Barnsley Metropolitan Borough Council
Head of Planning

Our ref : 153625-001

Planning Application reference 2025/0161 – Proposed mixed use scheme consisting of: Conversion of Grade II listed Coal Drops into Class E retail; new build extension to Coal Drops with Class E restaurant unit; Conversion of existing Regency House into Air BnB unit; and new build office and light industrial units (Class E) at Penistone Coal Drops, Regency House, Land at St Mary's Street, Penistone, Sheffield, S36 6DT

Sanderson Associates Consulting Engineers are appointed to advise the applicant for the above development on traffic and transportation matters and as such this letter has been prepared in response to the Highway Development Management consultation response dated 15 May 2025. A copy of this consultation response is attached at **Appendix A**.

Drawing 27845_A(02)04-P02 (Coal Drops - upper ground floor)

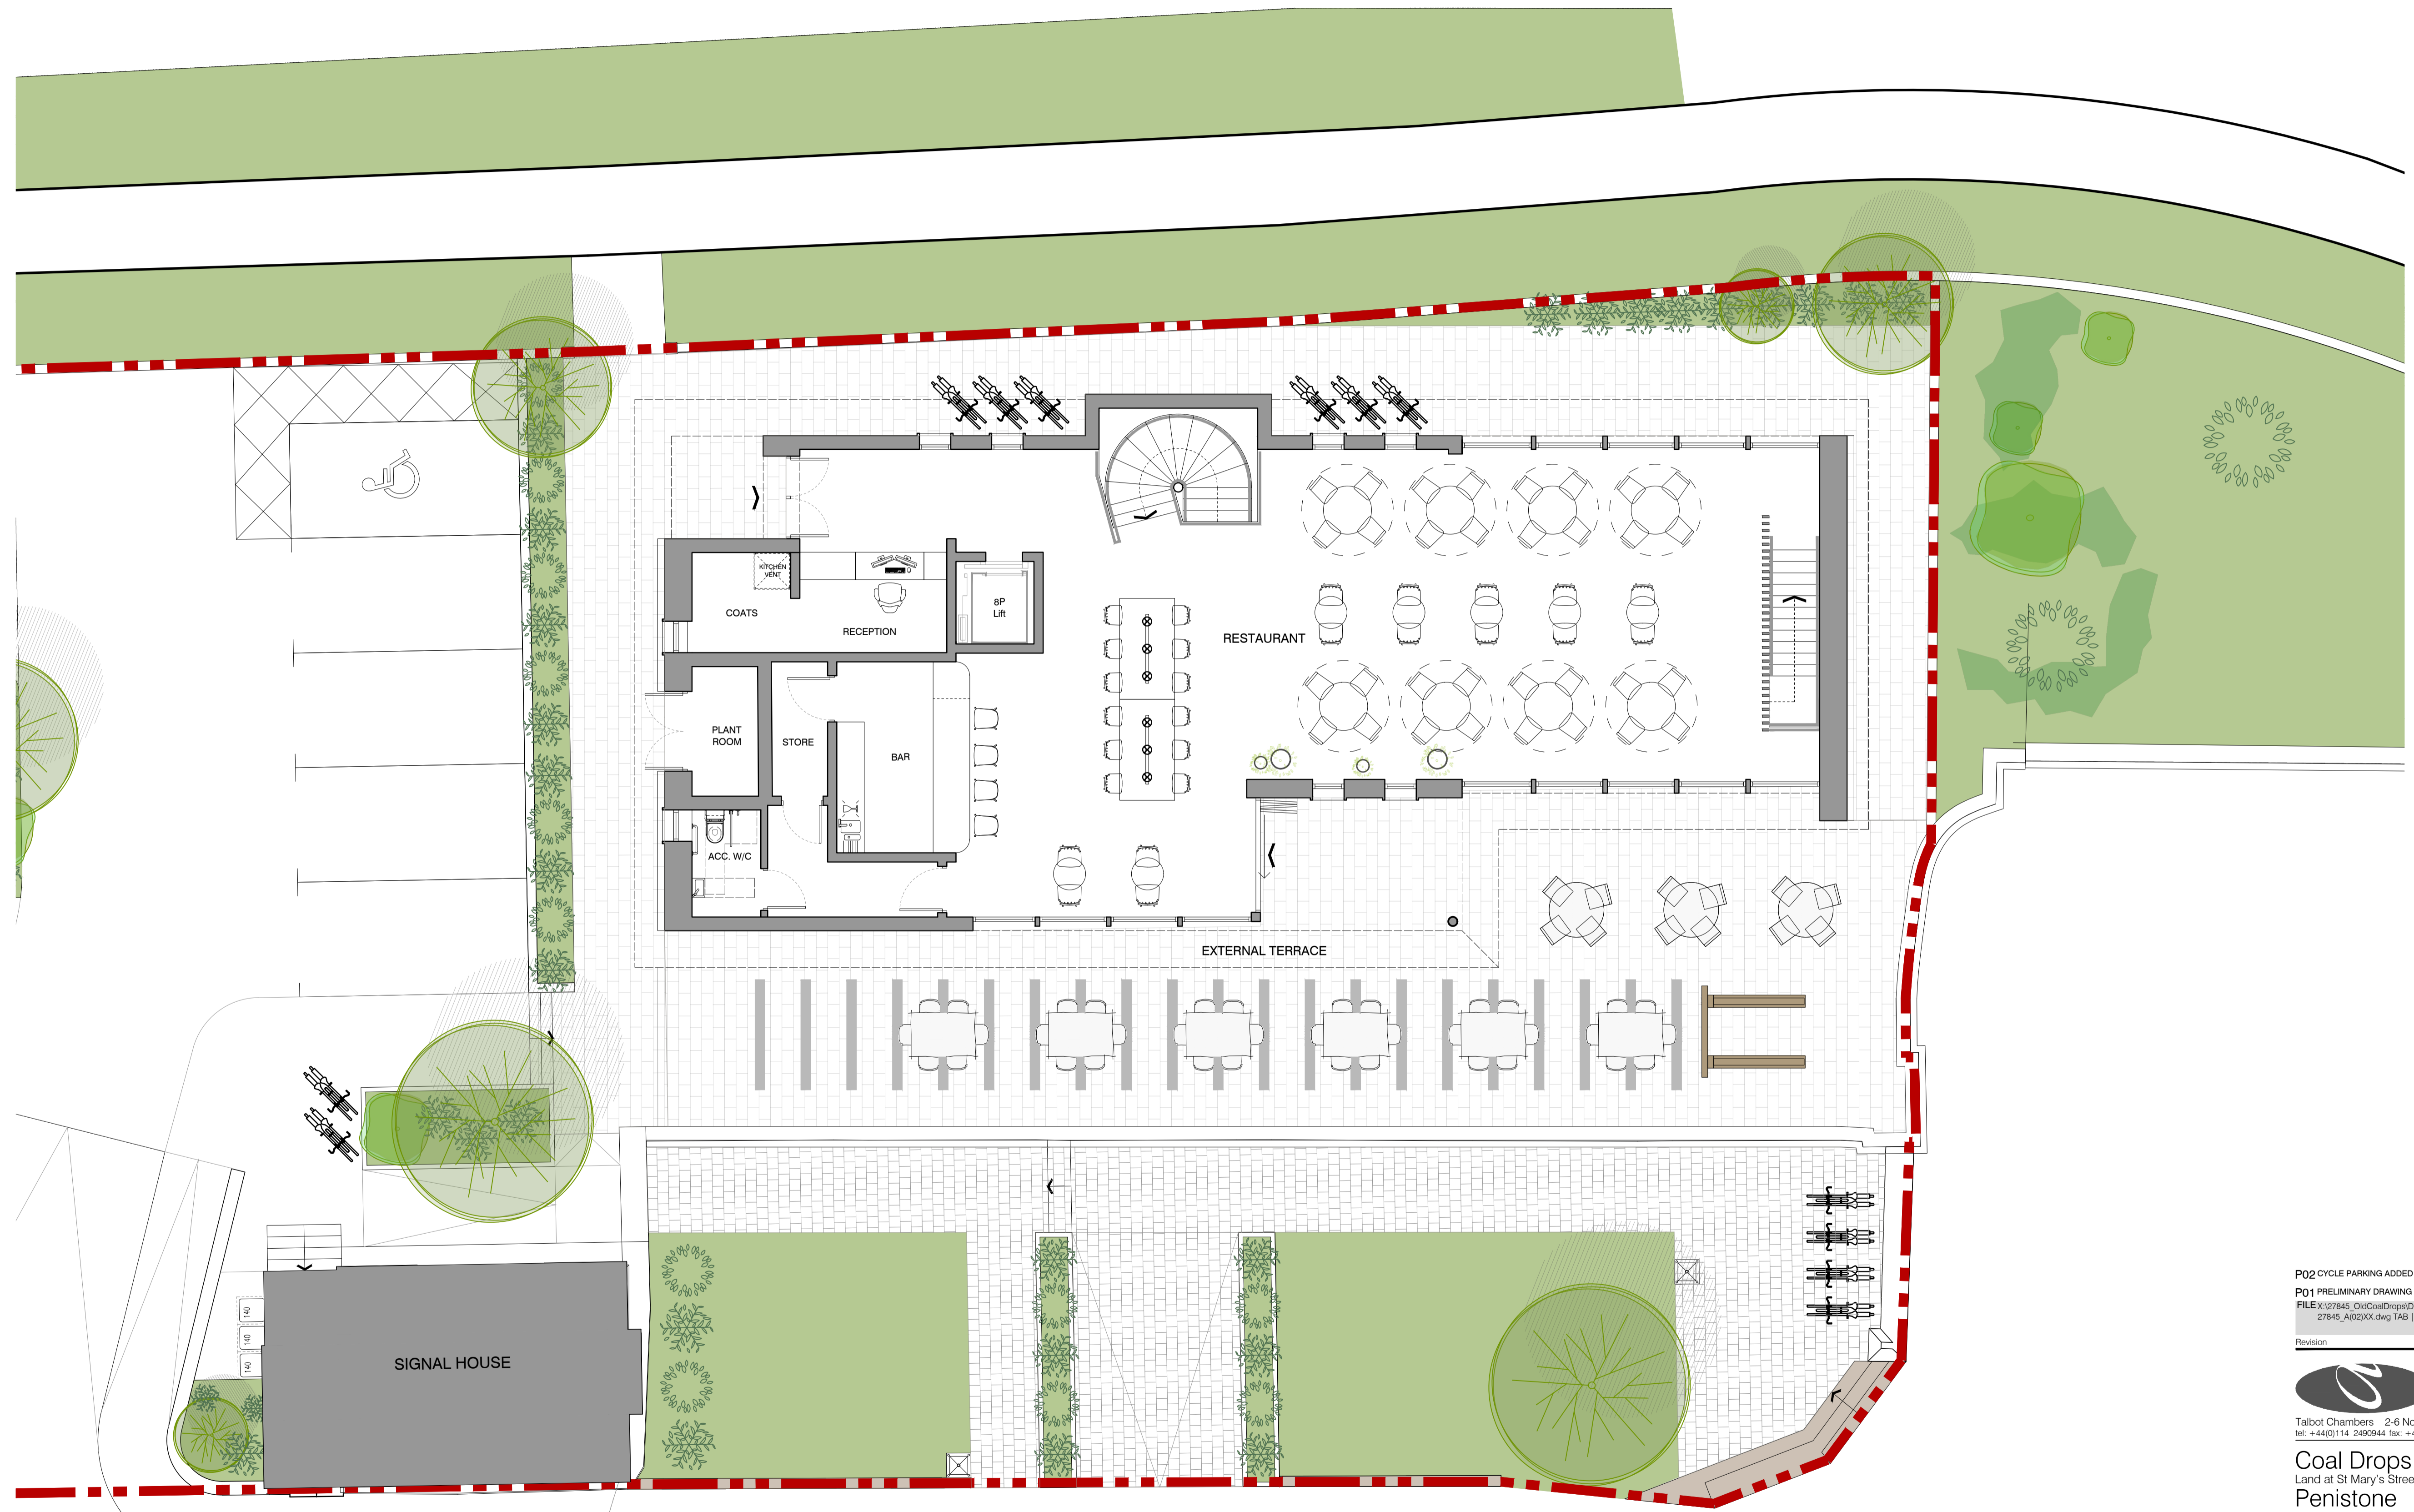
Cycle parking provision also appears inadequate, particularly given the site’s intention to attract users of the Trans Pennine Trail and the limited vehicle parking proposed. A greater quantity of secure, accessible cycle storage should be provided.

- Additional 6 cycle hoops to the rear of the proposed Pavilion Restaurant which would be located under the cover of the overhanging roof. These cycle parking spaces would be of particular benefit to visitors to the Pavilion Restaurant from the adjacent Trans Pennine Trail. (See Coal Drops upper ground floor plan at Appendix E)
